Board of Appeals Meeting

4.I. 3166 Dogwood Drive Variance Request

PLANNER'S REPORT

DATE: March 16, 2023
 TO: Adrienne Senter
 FROM: Lynn M. Patterson
 RE: Variance Application for 3166 Dogwood Drive with Tree Plan/Revisions

TREE AND
LANDSCAPE
PERMIT PLAN

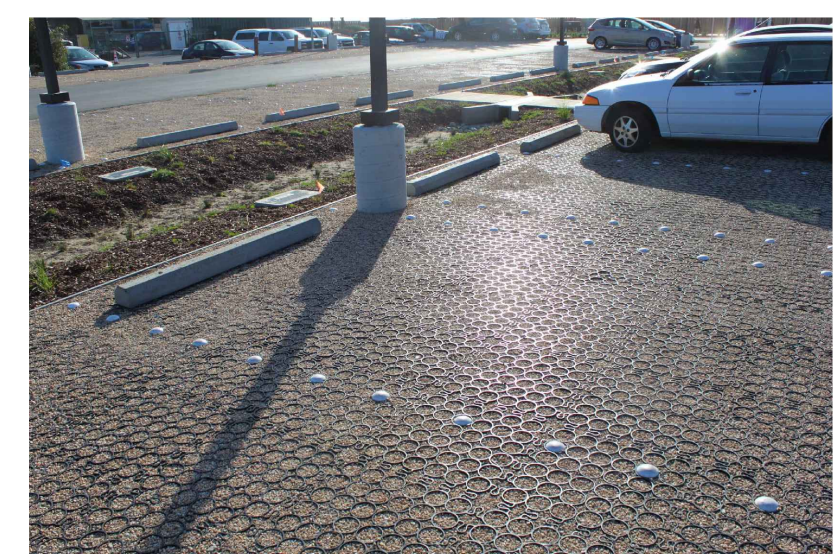
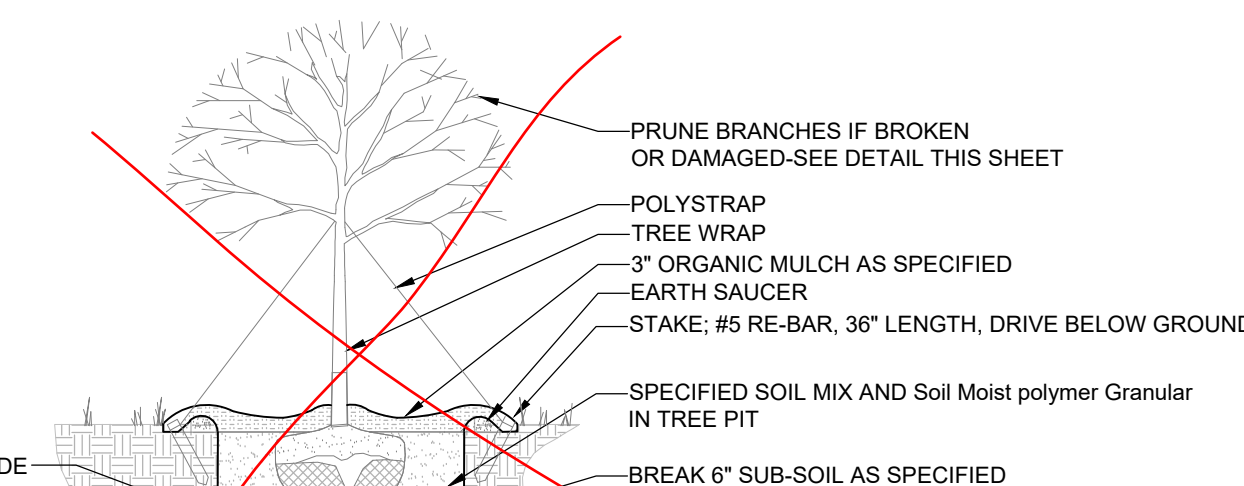
1. I don't have the arborist report for the adjacent tree, so it is not clear if they will be required to provide recompense (i.e., is the tree in fair or good condition?).
2. They are using an upright oak (very small canopy) as a recompense tree. Typically, this would not be appropriate for a recompense tree, but this is a tight site...and we still don't know if they have to plant them.
3. The perimeter tree is being used as a parking lot tree, but since there are only 3 of them, it exceeds the 20% allowable in the Ordinance. I can't OK that, but I also don't know what the parking requirement for the building is.

If the owner just wants more spaces, they should add the end island for a tree. If the parking spaces are required, it may be able to get a variance?

4. They have to include the lighting plan before this can be approved.

Add note that the Silva Cells will meet or exceed the minimum soil volume required
